CELLULAR SERVICE Bulletin

CSB-1116-1
Country : UK
Date : 11/13/2006
APC : F77
Repair Level : 1

Title W220 - GSM - W220 No display Issue
Model Effected W220

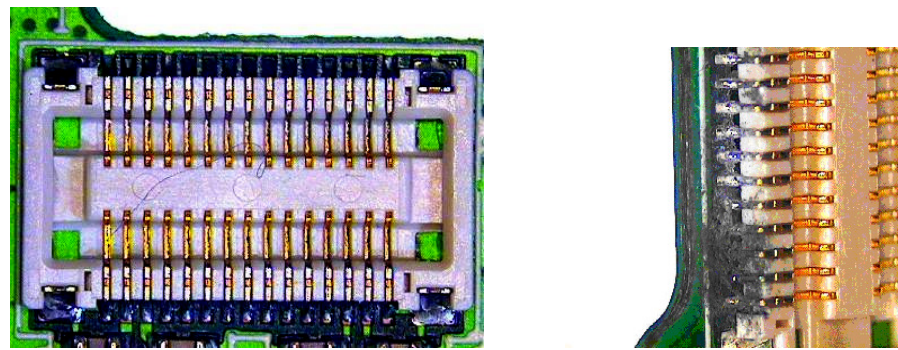
1. The root cause 1: LCM FPC copper circuits crack.

Corrective action for root cause1:
Wintek judge copper circuits crack (next to connector) was due to FPC test board bend by manual and it would possible cause LCM FPC copper circuits crack. There were two kind of FPC test board in Wintek. One is double copper layer, and the other is single copper layer. The double copper layer can bend the FPC and cause copper circuit crack.

In Wintek SMT process station, all test boards have been replaced with single layer test boards since 2006/7/23.
